Westinghouse Electric Company
Nuclear Power Plants
P.O. Box 355
Pittsburgh, Pennsylvania 15230-0355
USA

Subject: AP1000 Response to Request for Additional Information (TR 85)

AP1000 TECHNICAL REPORT REVIEW

RAI Response Number: RAI-TR85-SEB1-04

Figure RAI-TR85-SEB1-04-1 – ANSYS NI20 Model

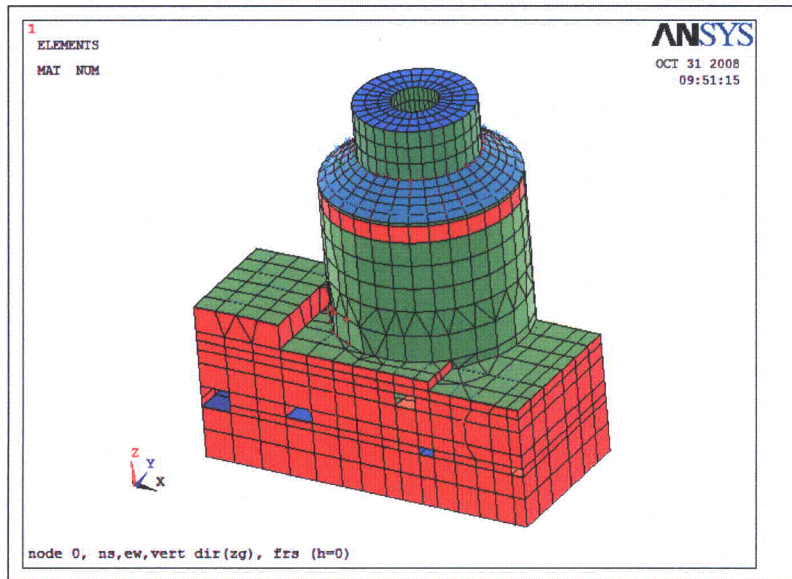
(2) Stability evaluations (for sliding and overturning) are based on a new 3D NI20 model response spectrum (linear no lift-off) analysis, enveloping all soil cases, using ANSYS. Westinghouse is requested to provide a full description of this model, range of soil springs used, analysis approach, and results. Since this model assumes no lift-off, Westinghouse is requested to confirm the adequacy of the existing stability evaluations by comparing the set of shear and overturning loads to those from one of the other seismic analyses that include the non-linear soil springs which permit lift-off effects. There is some inconsistency identified with

a. The 3D finite element analysis model [NI20], listed on page 1 of 7 of the RAI response, indicates that it was used in a response spectrum analysis with seismic input enveloping all soil cases for overturning and stability evaluation. Explain an apparent inconsistency with the analyses in the proposed revision to DCD Table 3G.1-1 in the RAI response.

(2) The stability evaluations (for sliding and overturning) are based on a 3D NI20 model time history analysis (linear no lift-off), and not a response spectrum modal analysis. This is consistent with Table 3G1-1 given in DCD Appendix 3G, Revision 17 (see also response to RAI-TR85-SEB1-34). The model used is shown in Figure RAI-TR85-SEB1-04-1. As noted in Section 2.4.2 to Technical Report 85, "Comparison of floor response spectra and the maximum member forces and moments for these two cases show that the liftoff has insignificant effect on the SSE response." Therefore, it has been concluded that liftoff will have insignificant effect on the forces and moments that are being used for seismic stability evaluation.

Figure RAI-TR85-SEB1-04-2 – Basemat Elements at Elevation 60'6"

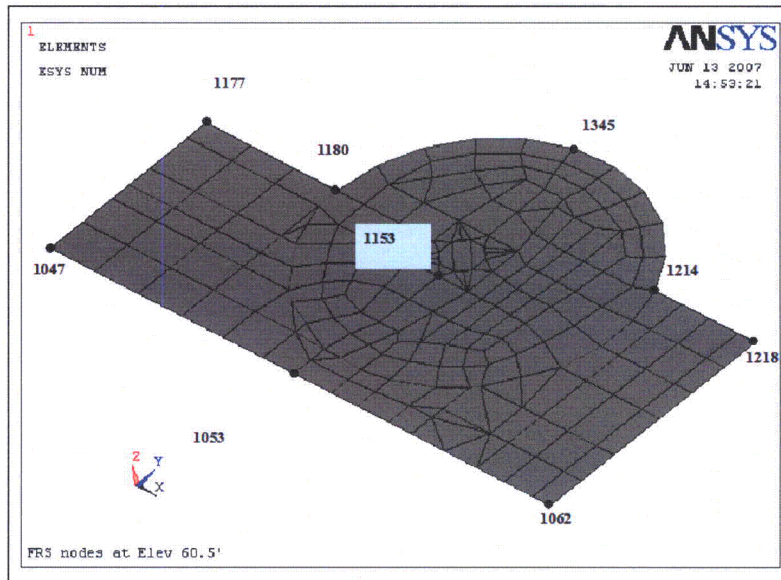
b. The revised DCD Table 3G.1-2, fifth row, indicates that the “Equivalent static analysis using nodal accelerations from shell model” was used in the “3D finite element model of the nuclear island basemat (NI05).” Explain to what “shell model” this refers and where is it described, and indicate to which specific model these acceleration values are applied in Table 3G.1-1 because no NI basemat NI05 model could be identified. This should be clarified within this Table 3G.1-2. Also, are these the same acceleration values identified in Table 2.6-2(a) in RAI-TR85-SEB1-22? Explain how Westinghouse can derive a single acceleration value at each elevation if it came from a 3D “shell model” that contains many nodes over a range of elevations?

In an effort to reduce the reliance on passive pressure to resist sliding, Westinghouse is no longer using a time history that envelopes all of the soil cases since it is too conservative. The seismic analysis was performed using the time history inputs as defined in DCD subsection 3.7.1.2, Revision 17. The analysis considered the hard rock case. All the base nodes were constrained to a single node, which in turn was fixed. This allowed the total Nuclear Island reaction forces to be taken from a single node location (node 1153). Node 1153 was selected as the central location, because it is located under the Center of Gravity (CG) for the NI structure. Shown in Figure RAI-TR85-SEB1-04-2 are the elements in the basemat at elevation 60'-6". Key nodes at the Elevation 60' 6" for the basemat of the NI20 model are shown for reference. Node 1153 is centrally located, and all the nodes in the basemat at this elevation are rigidly fixed to this node for the analysis.

Single acceleration values at each elevation are an average of the accelerations of each node at an elevation from the 3D shell model. This is acceptable since this will result in representative load acting on the basemat.
